M9808A-02

# Information Only Service Note

# M9808A PXIe Vector Network Analyzer

False alarm on self-test failure on firmware revision of A.13.40.02 - DDR3 memory removal

#### Self-test

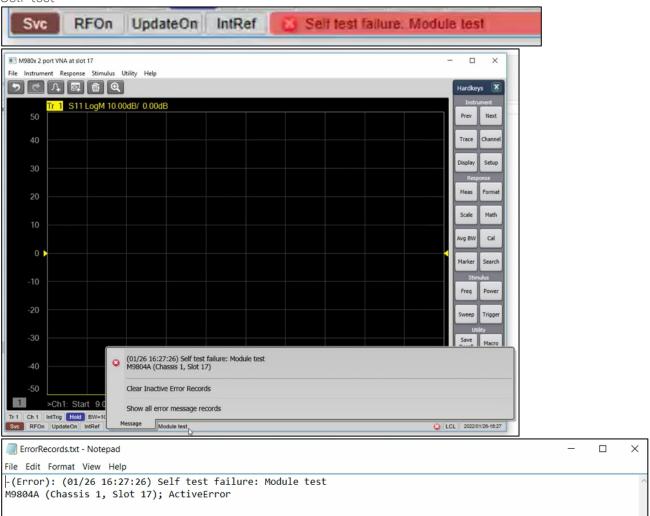
The on board DDR 3 memory in VNA is not in use since its release. With the removal of DDR 3 memory IC on newer M980xA VNA, right after firmware is launched, false alarm (self-test failure) will be reported as shown. This has no impact to VNA performance and specifications.

Similarly, firmware will report a false failure in Operator check. Shown are the error messages example on VNA firmware UI.

Since this DDR3 memory is not in use, newer firmware revision no longer consider it as the failure. Keysight recommends keeping VNA firmware up-to-date whenever it is possible.

For users with firmware revision of A.13.40.02, Update firmware to revision A.13.70.02 or newer to resolve this false alarm on self-test.
